SOUTH HEYWOOD ENABLING WORKS

DRAINAGE NOTE

OUR REF. NO. 70089657/DI/R/003

DATE: DECEMBER 2024

DRAWING NO: SOHW-WSP-PSS-ENAB-DR-D-0001

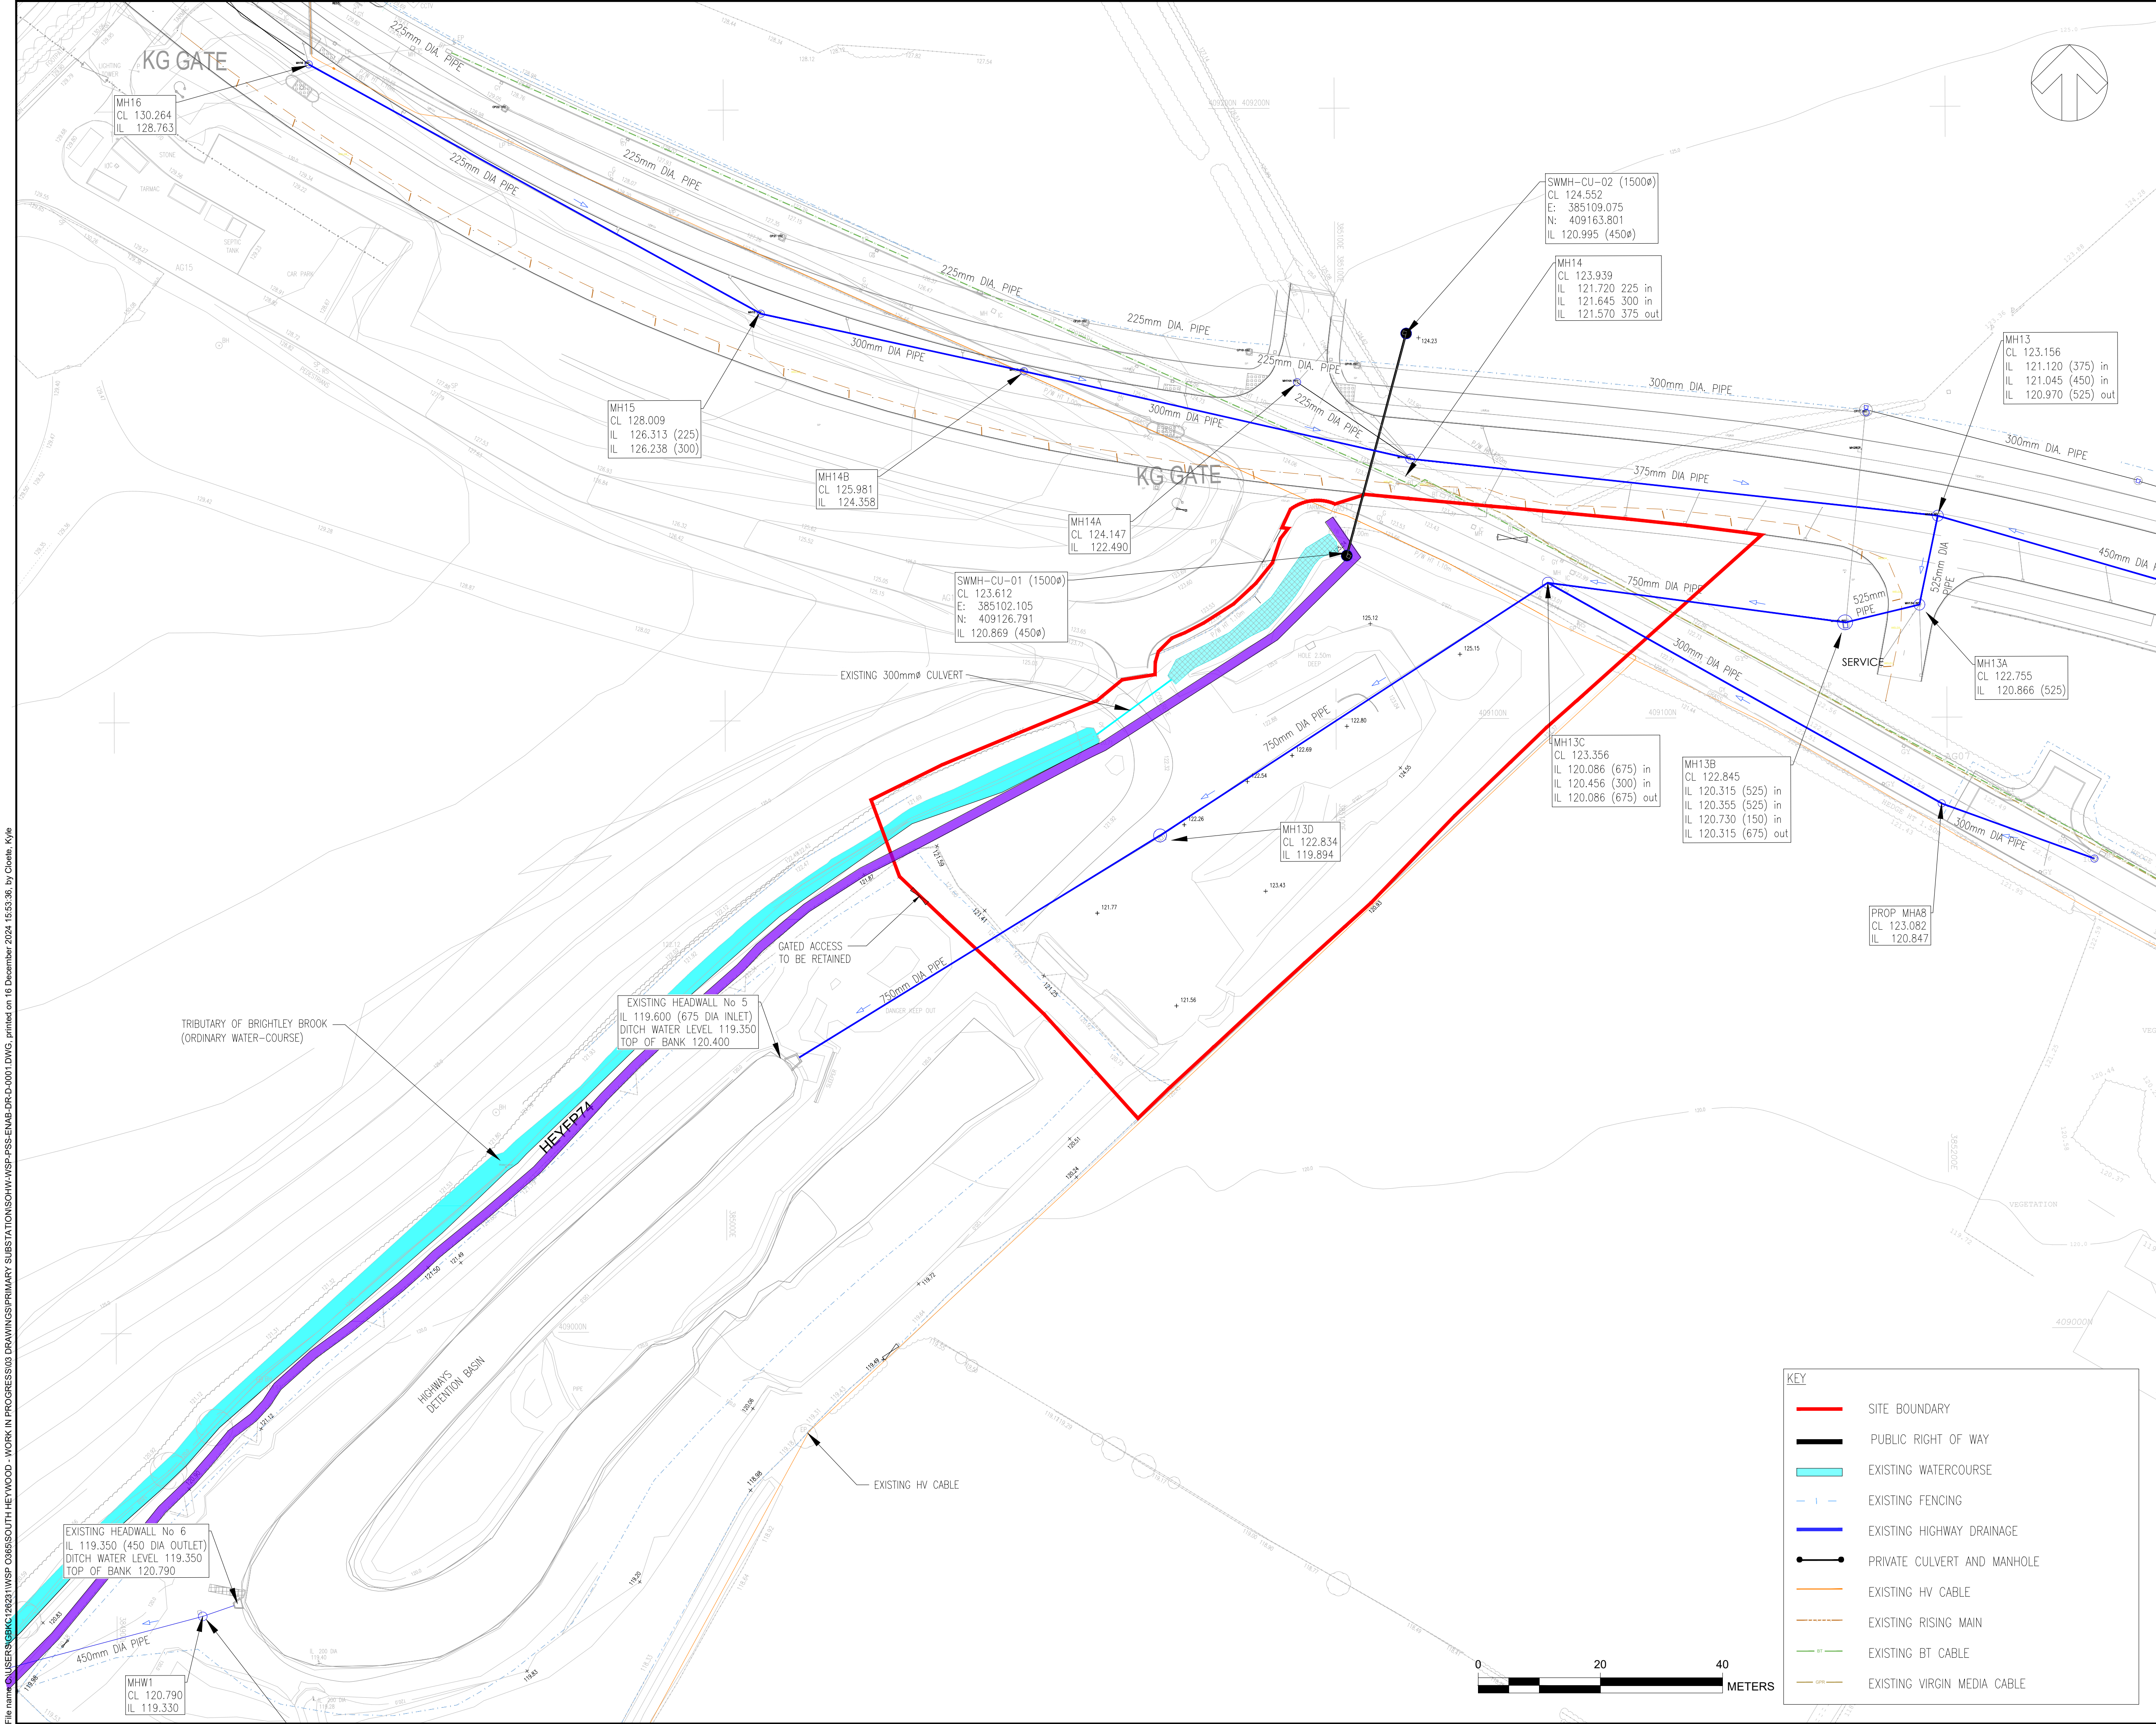
- 3.1.2. The highway drainage system briefly comprises the following elements as shown on drawing 'SOHW-WSP-PSS-ENAB-DR-D-0001 – Existing Site Plan' in **Appendix C**.

- Flows from the newly constructed QE2 Way and the legacy drainage from Hareshill Road converge at MH13C, located towards the northeast corner of the site.

- Downstream of MH13C the flow travels southwest approximately 75m to MH13D.
 - From MH13D the flow is directed a further 70m southwest through the proposed development site and discharges into the existing highway drainage pond via a precast concrete headwall.

- The pond discharges into the ordinary watercourse immediately to the west via a 450mm diameter pipe.
- 3.1.3. To facilitate future development it is therefore proposed to divert the existing highway drainage between MH13C and the existing pond headwall around the footprint of the site.
